DESCRIPTIVE REPORT

Registry No. H-11006

General Locality Southwest Prince William Sound
Sublocality Western Coast of Montague Island- Vicinity
of Point Bazil including Hanning Bay

**EVALUATION REPORT
H11006**

Figure 3: H11006 Survey Junctions

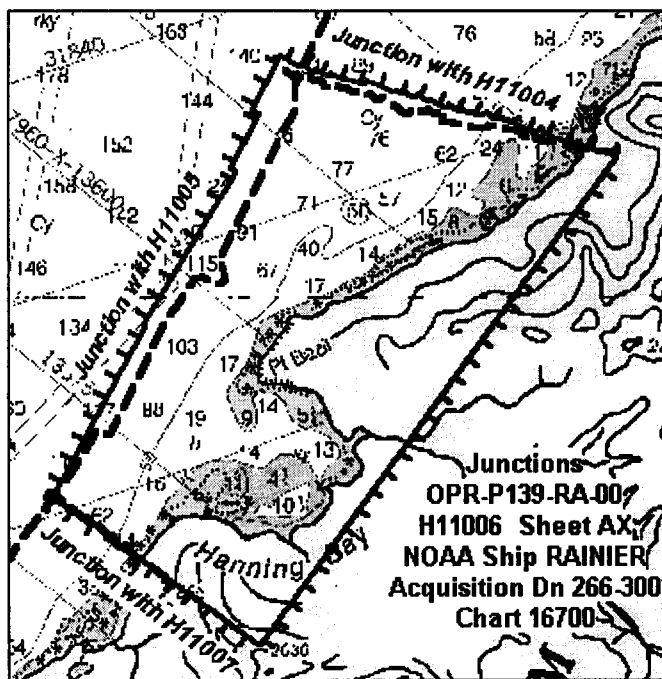
Soundings from surveys H11004 and H11005 were generally within 1 fathom of the soundings from H11006. *Concur*

At the time of this report, processing of H11007 was not complete. Comparisons with H11006 will be discussed in the Descriptive Report for H11007.

Final comparisons will be made at the Pacific Hydrographic Branch (PHB) after the application of smooth tides. *Concur*
